Second Five-Year Review Report

**For
Homestake Mining Company Superfund Site
Cibola County, New Mexico**

September 2006

FIVE-YEAR REVIEW
Homestake Mining Company Superfund Site
EPA ID# NMD007860935
Cibola County, New Mexico

Figure 22 Uranium Concentrations of the Lower Chinle Aquifer (Reproduced from Hydro-Engineering 2006)

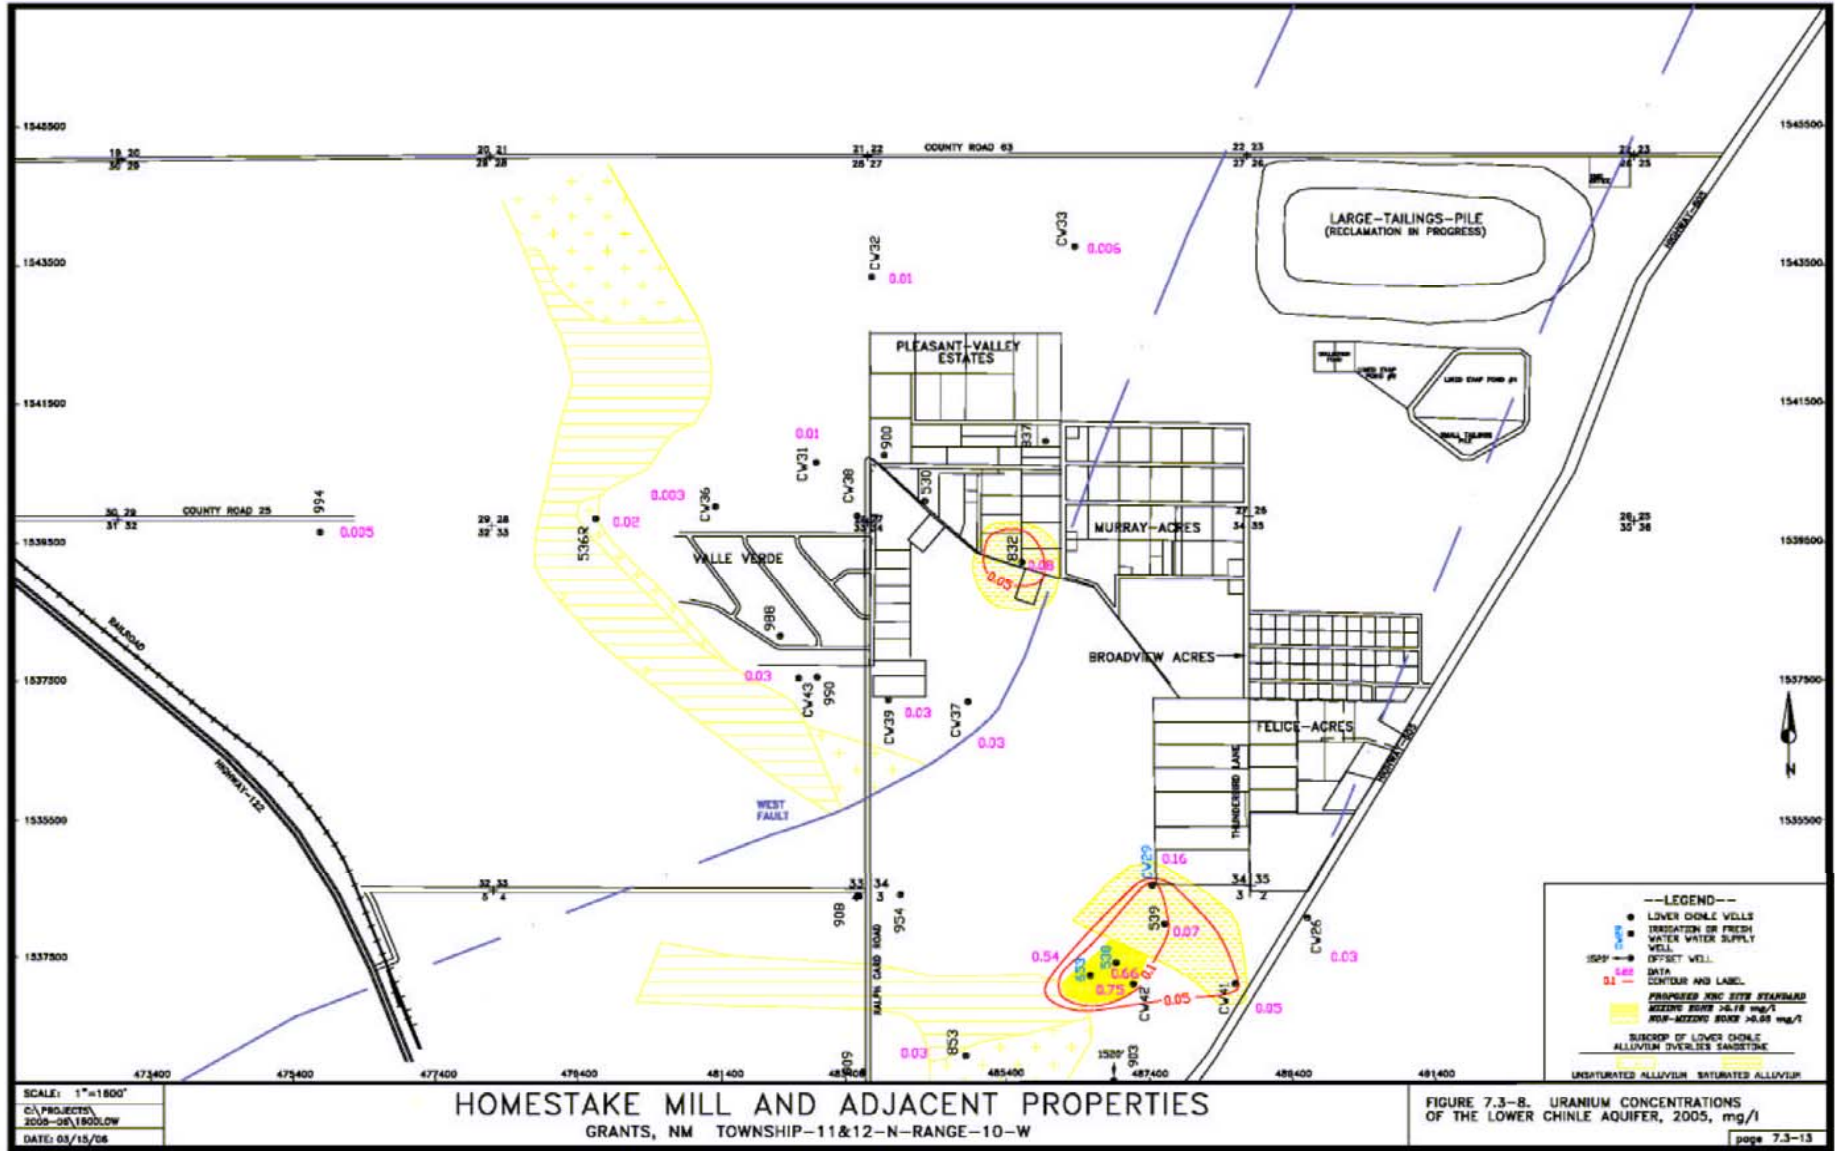
Figure 22 provides isoconcentration plots of uranium in the Lower Chinle aquifer during 2005. The map also depicts the faults and locations where the aquifer subcrops beneath the overlying alluvium. The map shows one area within the mixing zone of the Lower Chinle aquifer between the two faults, where the uranium concentrations in year 2005 were above the corresponding mixing zone background concentration of 0.18 mg/l. The uranium concentrations in the Lower Chinle adjacent to the mixing zone also exceeded the estimated Lower Chinle background concentration of 0.03 mg/l. The uranium concentrations in one Lower Chinle aquifer well (Well 832) located west of the West Fault also exceeded the estimated Lower Chinle background concentration of 0.03 mg/l. The uranium concentration in this well of 0.08 mg/l does not appear to be Site related because the well is located west of the West Fault where the water levels are higher than in the portion of the Lower Chinle aquifer located east of the West Fault.
